UNITED STATES PATENT AND TRADEMARK OFFICE

APPLICATION NO.	FILING DATE	FIRST NAMED INVENTOR	ATTORNEY DOCKET NO.	CONFIRMATION NO.
10/072,707	02/05/2002	Alain Houle	CISCP730	1909
54406	7590	09/21/2005	EXAMINER	
AKA CHAN LLP / CISCO 900 LAFAYETTE STREET SUITE 710 SANTA CLARA, CA 95050			KIM, DAVID S	
			ART UNIT	PAPER NUMBER
			2633

Office Action Summary

DETAILED ACTION

Fig. 1

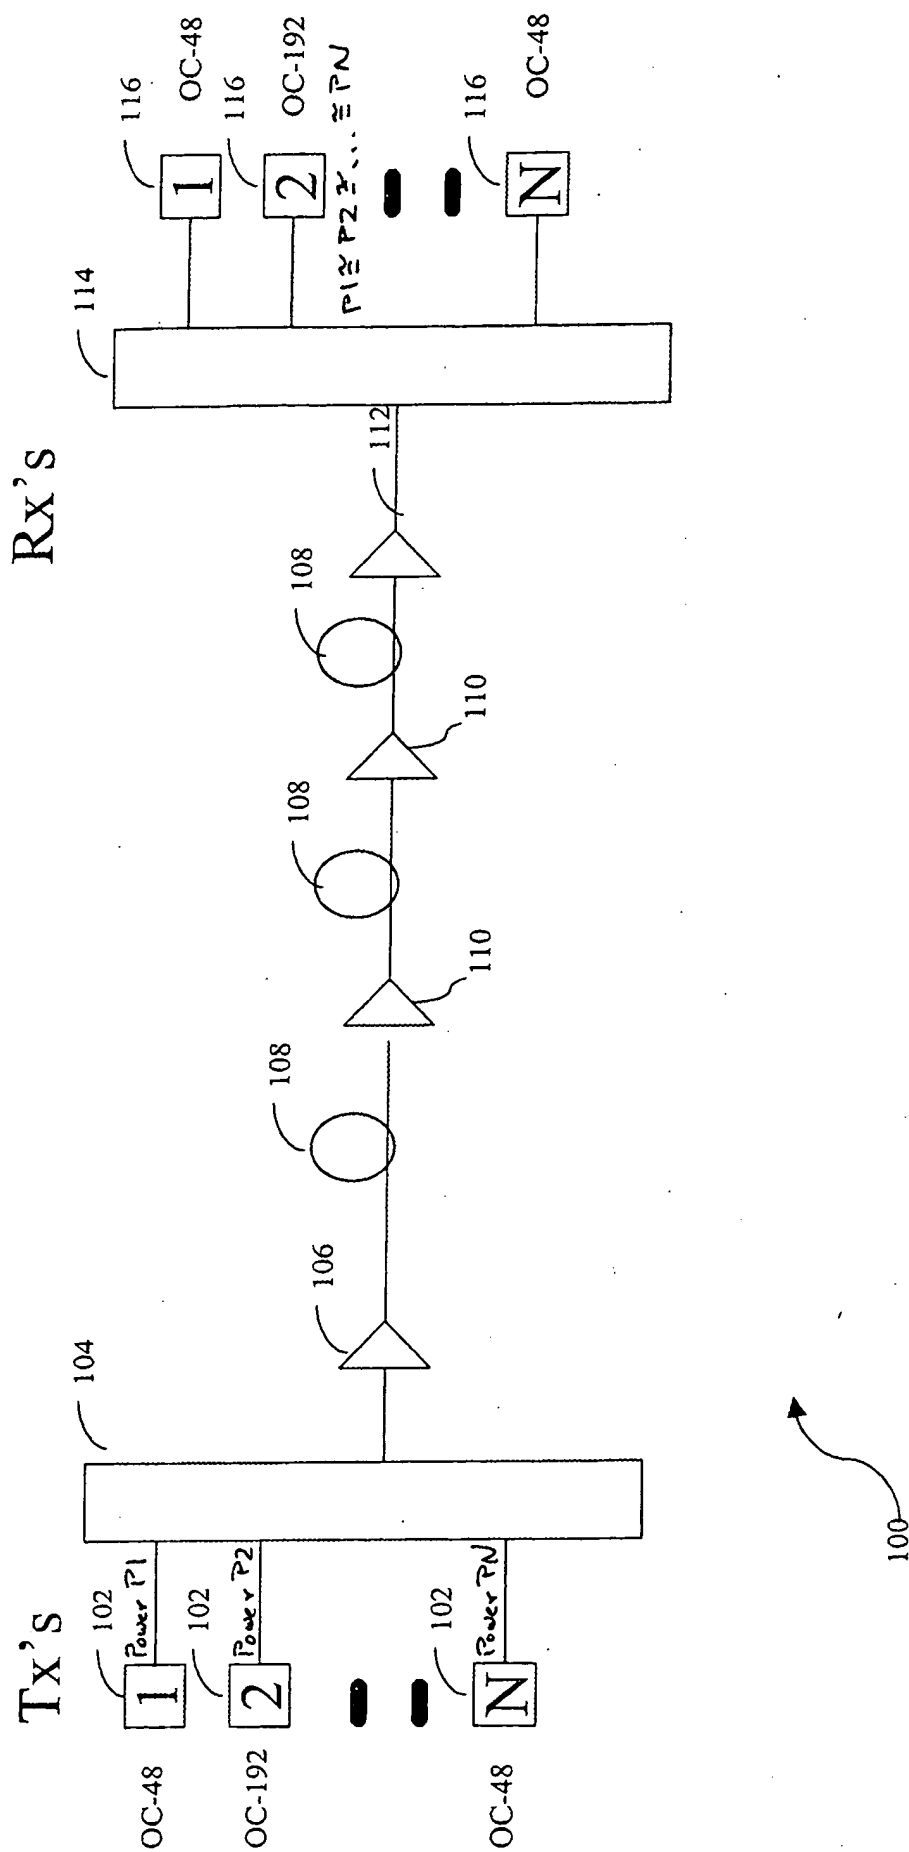
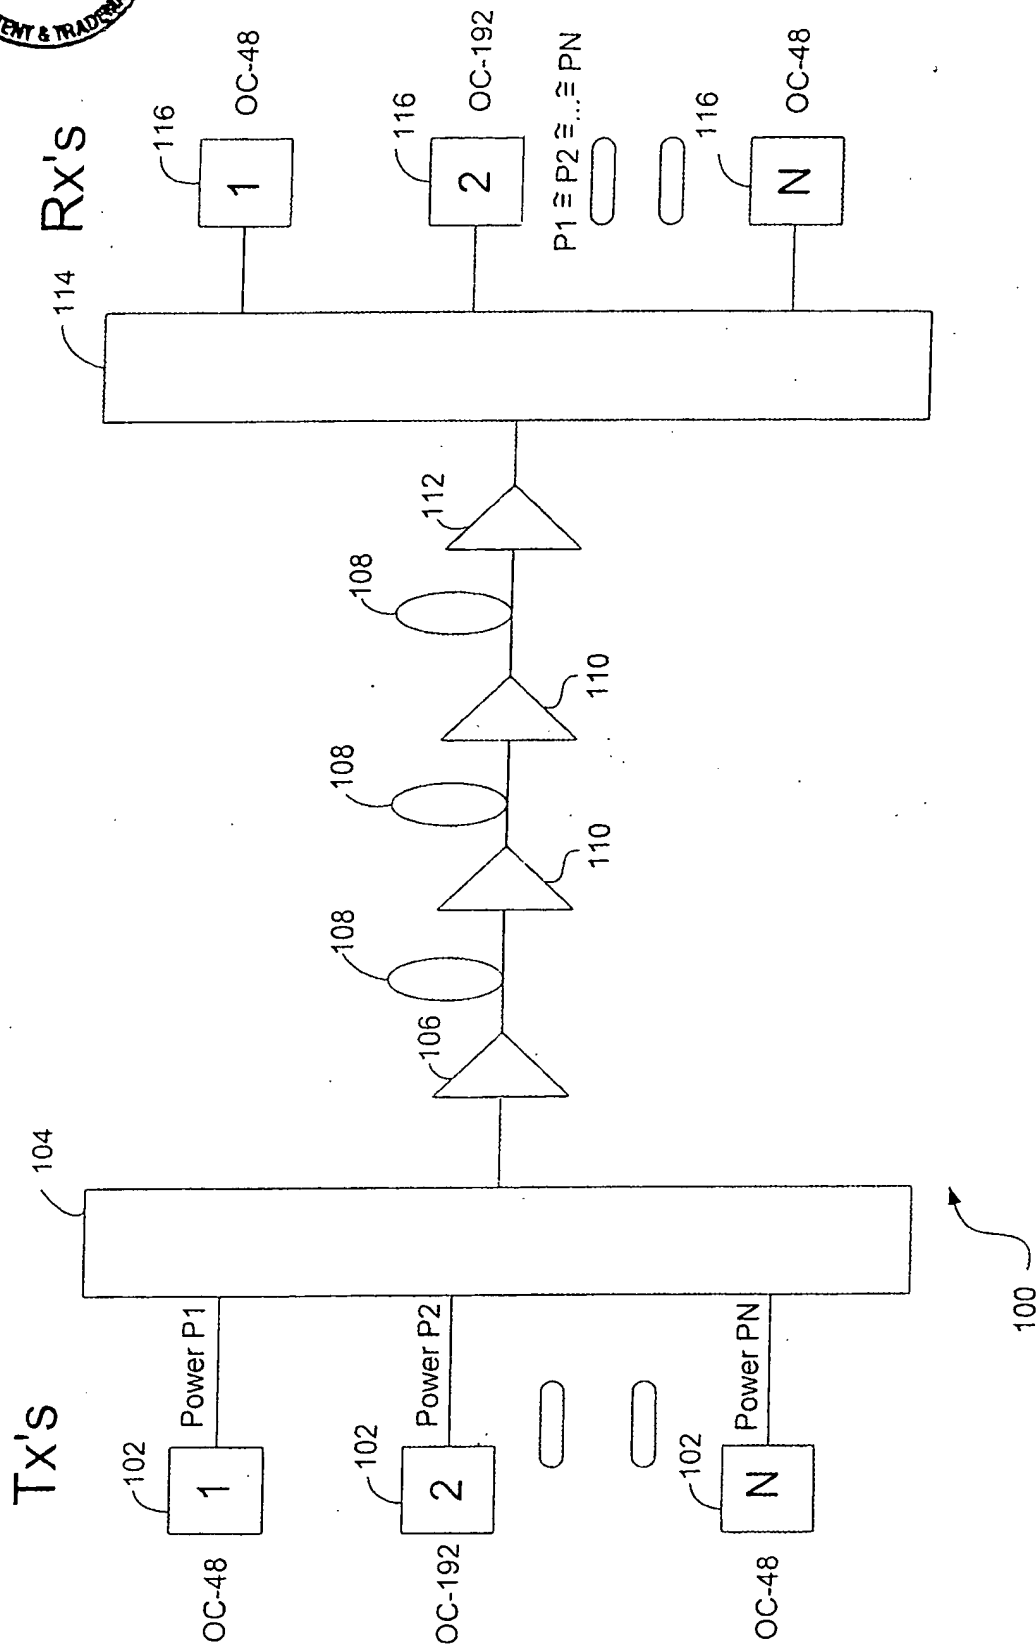
1. Applicant's response to the objections to the drawings in the previous Office Action (mailed 17 December 2004) is noted and appreciated. The replacement drawings were received on 24 March 2005. Figs. 2-3 and 4B are approved. Figs. 1 and 4A are disapproved. The drawings are still objected to under 37 CFR 1.83(a). The drawings must show every feature of the invention specified in the claims.

(claim 7) wherein said first modulated optical signal and said second modulated optical signal have substantially similar power levels *when multiplexed together* (emphasis Examiner's) and

(claim 21) wherein *amplified* power levels of said first modulated optical signal and said second modulated optical signals are substantially similar (emphasis Examiner's).

Fig. 1 shows substantially similar power levels only *when received*. Fig. 1 does not show substantially similar power levels when the optical signals are *multiplexed together* or when the optical signals are *amplified*.

Disapproved by DSK
10 SEPTEMBER 2005

Therefore, the following features must be shown or the feature(s) canceled from the claim(s):

No new matter should be entered.
